01-22-05 - Update Programming Engine/Motor Control Module - J623- for Various Concerns

Release date: 9/22/2022

Revision Table			
Instance Number	Published Date	Version Number	Reason For Update
2068071/1	9/22/2022	01-22-05	Original publication.

Figure 1.

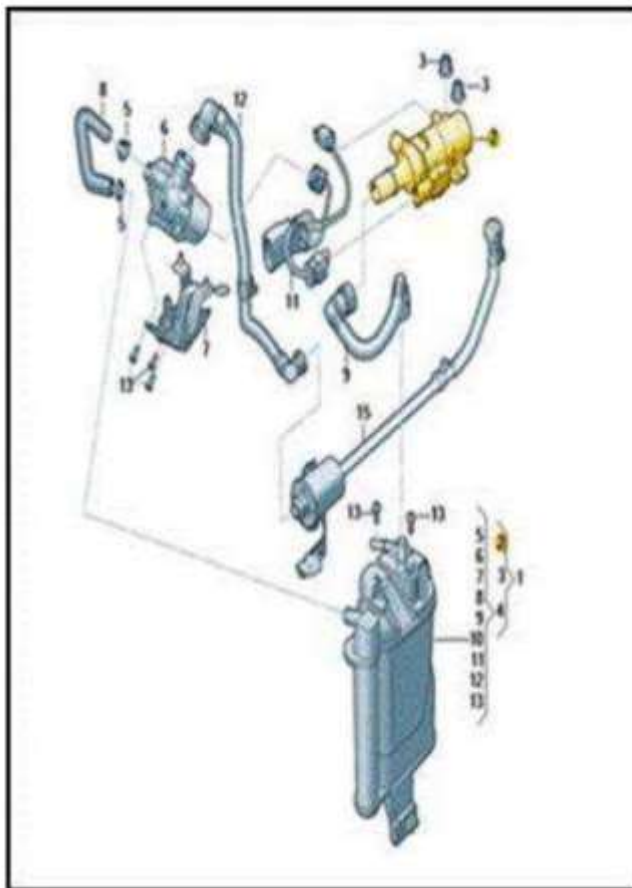
In addition to the software improvement, there is also an improvement to the FTIV (fuel tank isolation valve/tank switch-off valve -**N288**-) (Figure 1.), which is necessary in preventing erroneous occurrences of the P2421 fault code.

The FTIV / Tank switch-off valve -**N288**- currently installed on the vehicle must be inspected, to verify whether an improved part has already been installed. The FTIV / Tank switch-off valve -N288- is mounted to the EVAP canister assembly, as shown below.

Remove the EVAP canister assembly and inspect the face of the FTIV / Tank switch-off valve -**N288**-. If the part is already updated, it will have a white paint marking or "02S" printed after the part number, as shown in Figure 2 and Figure 3.

- If the part has a white paint mark or "02S", the FTIV / Tank switch-off valve -N288- is already the updated component. In this case DO NOT replace it, and instead reinstall the EVAP canister assembly. Only the software update will be required.

- If there is no white paint mark or “02S” visible on the FTIV / Tank switch-off valve -**N288**-, the component must be replaced in addition to the software update. Always refer to ETKA for the most up to date part number information.
